ISSUE	DATE	DRAWN	CHECKED	DESCRIPTION
DRAWING TITLE	GA PROPOSED SECTION D-D			
DRAWING NO.	CTH-PUR-MP-ZZ-DR-A-92203			
REVISION	P04			
SIZE & SCALE	A1L 1:200			
DRAWING STATUS	Issued for Planning

CLIENT	Lendlease	
PROJECT	Camden Town Hall	
JOB NUMBER	238664

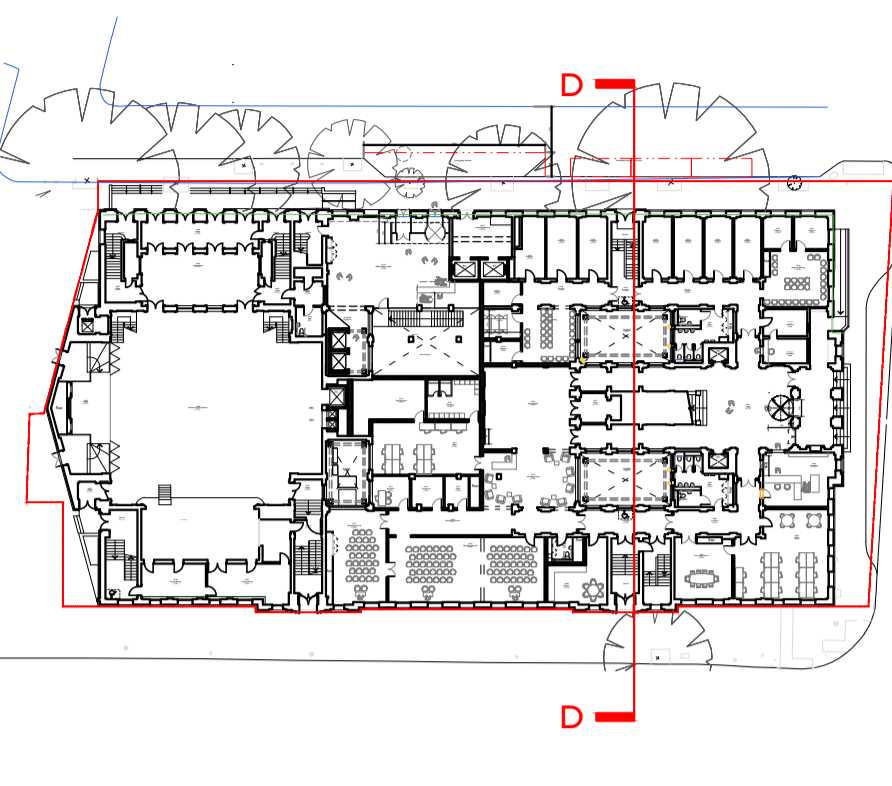
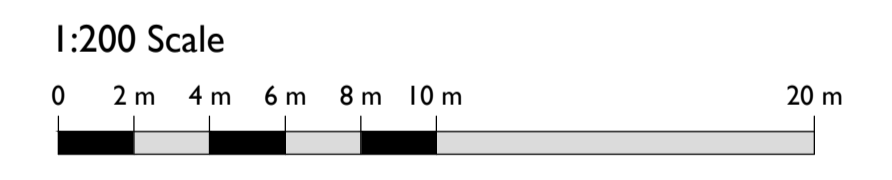
REVISION: Roof structure to area of 1940s extension updated to remove loading on existing steel structure. New columns introduced in Lightwells 1 & 2 on new foundations. Amended arrangement of ASHP units on roof with greater sound attenuation and acoustic louvered screening to protect from noise bleed to neighbouring properties
